Access Compliance Report

Public Rights-of-Way

(Curb Ramps)

Intersection ID: 53088	Main Street: KENMERE_LN	Cross Street: DEERFIELD_MANOR_DR	Location: NE
ADA ID: 9313ABF49948	Ramp Type: Perp	Initial Pass/Fail: Fail	Overall Compliance: No
Severity Score: 12.5			
Codes/Mitigation Info/Possible Solution		Field Measurements/Component Compliance

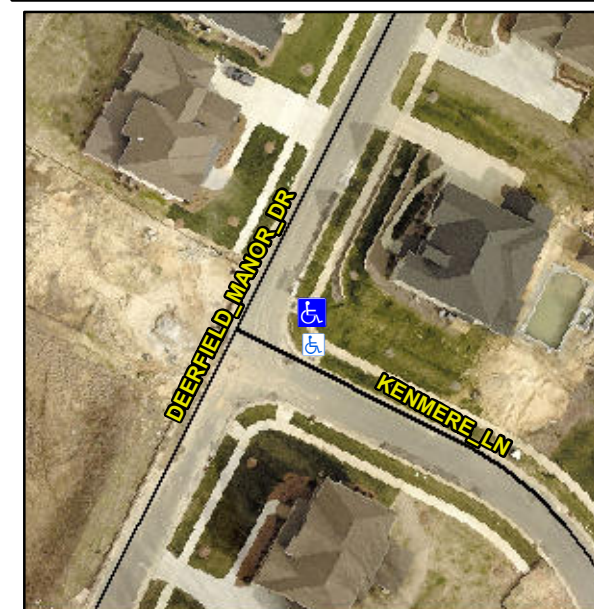
Not Found, R304.2.2

Compliance	Description	Data	Compliance	Description	Data
N/A	Ramp Length (in)	100.0	No	Ramp Slope (%)	11.6
Yes	Ramp Width (in)	48.0	Yes	Ramp XSlope (%)	0.2
N/A	Flare Type LT	N/A	N/A	Flare Type RT	N/A
N/A	Flare Slope LT (%)	N/A	N/A	Flare Slope RT (%)	N/A
N/A	Flare Traversable LT?	N/A	N/A	Flare Traversable RT?	N/A
N/A	Landing Length (in)	N/A	N/A	DWS Provided?	N/A
N/A	Landing Width (in)	N/A	N/A	DWS Contrast?	N/A
N/A	Landing Slope (%)	N/A	N/A	DWS Length (in)	N/A
N/A	Landing X Slope (%)	N/A	N/A	DWS Full Width?	N/A
N/A	Landing Curb? (Y/N)	N/A	N/A	DWS Offset (in)	N/A
N/A	Shared Landing?	N/A			
N/A	Gutter Ponding?	N/A	N/A	Gutter Slope (%)	N/A
N/A	Gutter Lip Ht (in)	N/A	N/A	Gutter X Slope (%)	N/A
N/A	Painted X Walk1?	No	N/A	Painted X Walk2?	N/A
	X Walk 1 Direction	To NW		X Walk 2 Direction	N/A
N/A	X Walk 1 Width (in)	N/A	N/A	X Walk 2 Width (in)	N/A
	X Walk 1 Slope (%)	4.4		X Walk 2 Slope (%)	N/A
	X Walk 1 X Slope (%)	2.5		X Walk 2 X Slope (%)	N/A

Remove & Replace Entire Ramp.
